AWC Number of Water Body: (if known) 247-41-10200-2120-3018 (-0010), (-0020), (-0030)

Name of Water Body: (if known) *Gene Creek+Lake, Ruth Lake, Jack Lake
 Official USGS Name *Local or Unofficial Name

Nomination # : 25-014
 Revision Year : 2026
 Revision(s) to: Atlas Both
 Catalog
 Revision Code(s) : C-9, A-1, A-2

Map #1

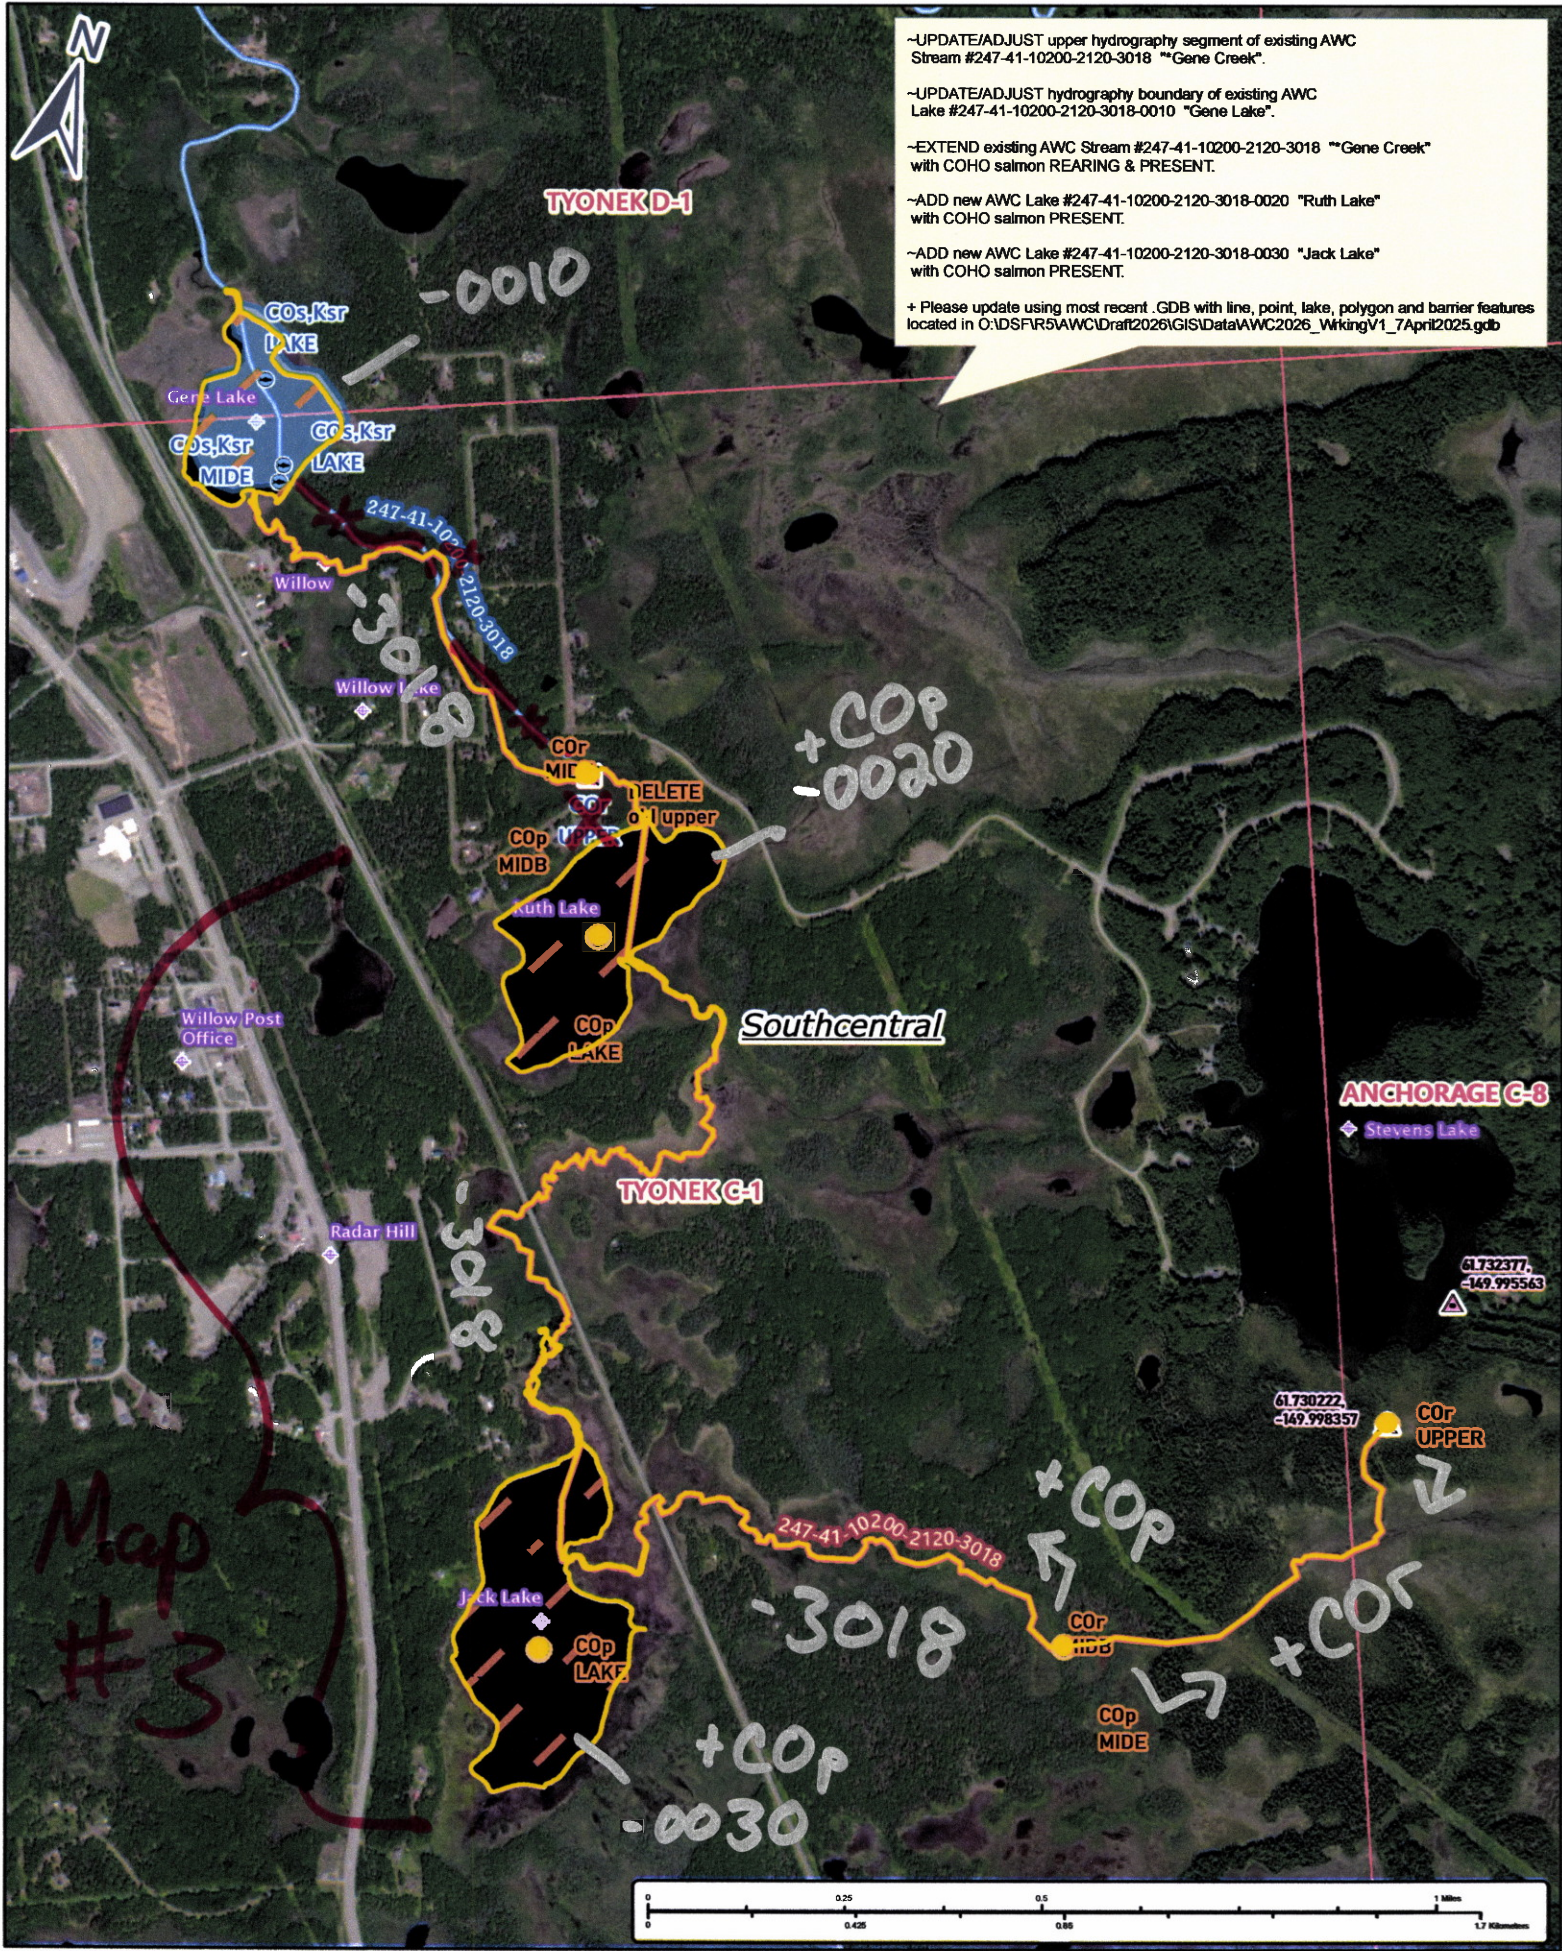
- UPDATE/ADJUST upper hydrography segment of existing AWC Stream #247-41-10200-2120-3018 "Gene Creek".
- UPDATE/ADJUST hydrography boundary of existing AWC Lake #247-41-10200-2120-3018-0010 "Gene Lake".
- EXTEND existing AWC Stream #247-41-10200-2120-3018 "Gene Creek" with COHO salmon REARING & PRESENT.
- ADD new AWC Lake #247-41-10200-2120-3018-0020 "Ruth Lake" with COHO salmon PRESENT.
- ADD new AWC Lake #247-41-10200-2120-3018-0030 "Jack Lake" with COHO salmon PRESENT.
- + Please update using most recent GDB with line, point, lake, polygon and barrier features located in C:\DPS\RSVAWC\Deltant2026\GIS\DeltantAWC2026_WrkingV1_7_April2025.gdb

Map #2

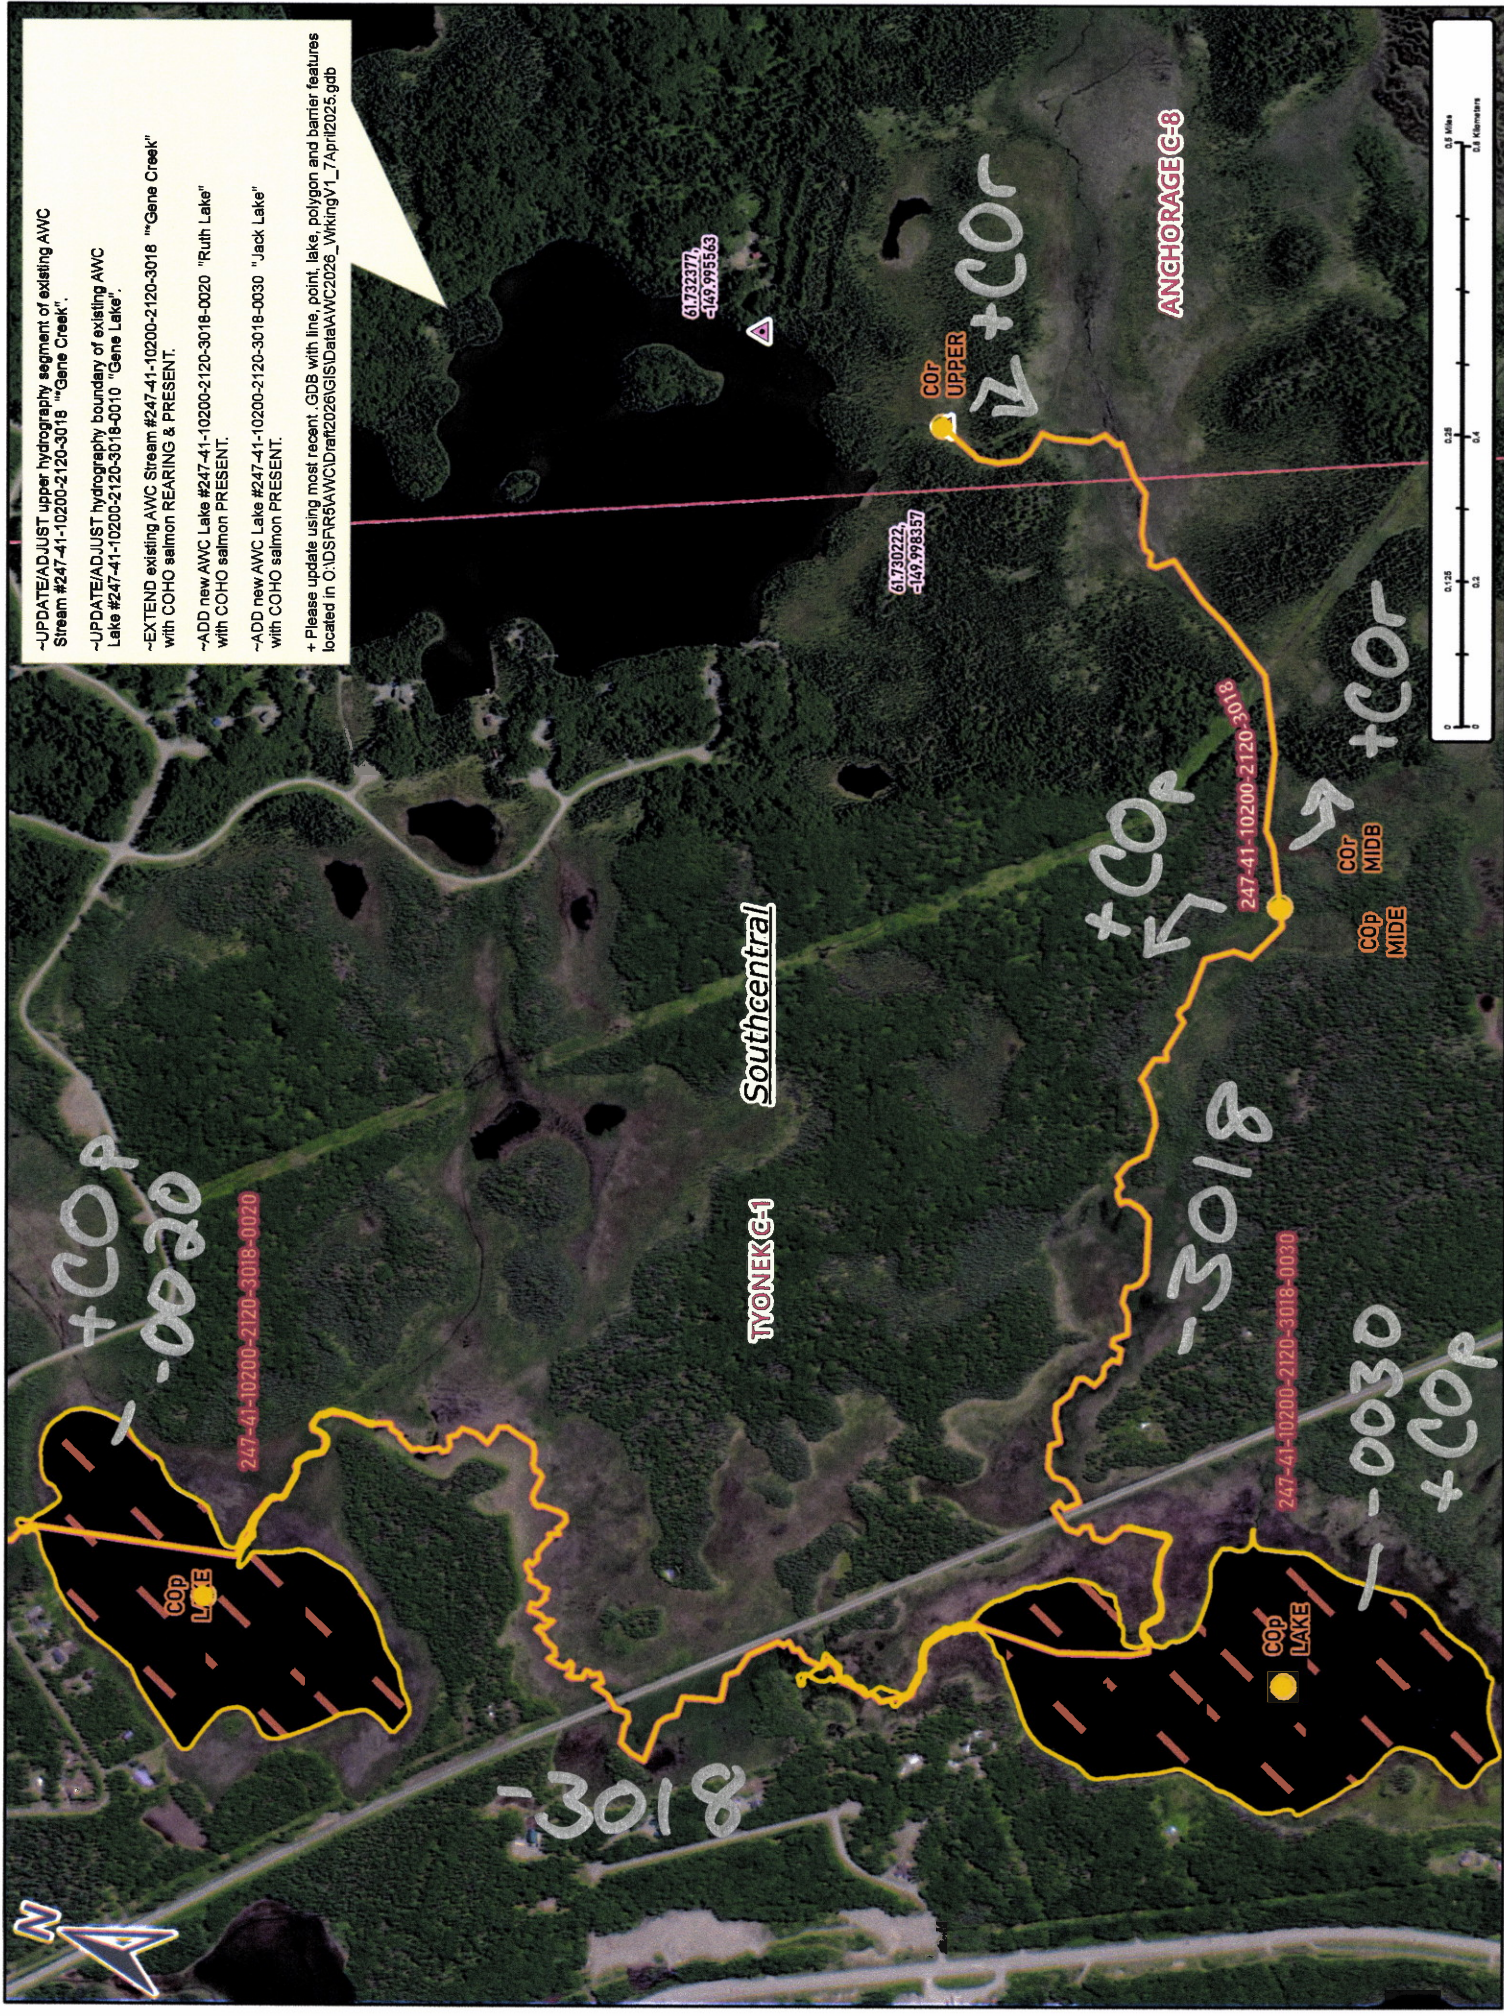
- UPDATE/ADJUST upper hydrography segment of existing AWC Stream #247-41-10200-2120-3018 "Gene Creek".
- UPDATE/ADJUST hydrography boundary of existing AWC Lake #247-41-10200-2120-3018-0010 "Gene Lake".
- EXTEND existing AWC Stream #247-41-10200-2120-3018 "Gene Creek" with COHO salmon REARING & PRESENT.
- ADD new AWC Lake #247-41-10200-2120-3018-0020 "Ruth Lake" with COHO salmon PRESENT.
- ADD new AWC Lake #247-41-10200-2120-3018-0030 "Jack Lake" with COHO salmon PRESENT.
- + Please update using most recent .GDB with line, point, lake, polygon and barrier features located in C:\USFRS\AWC\Dir\10200\GISData\AWC2026_Wirking_V1_7_April2023.gdb
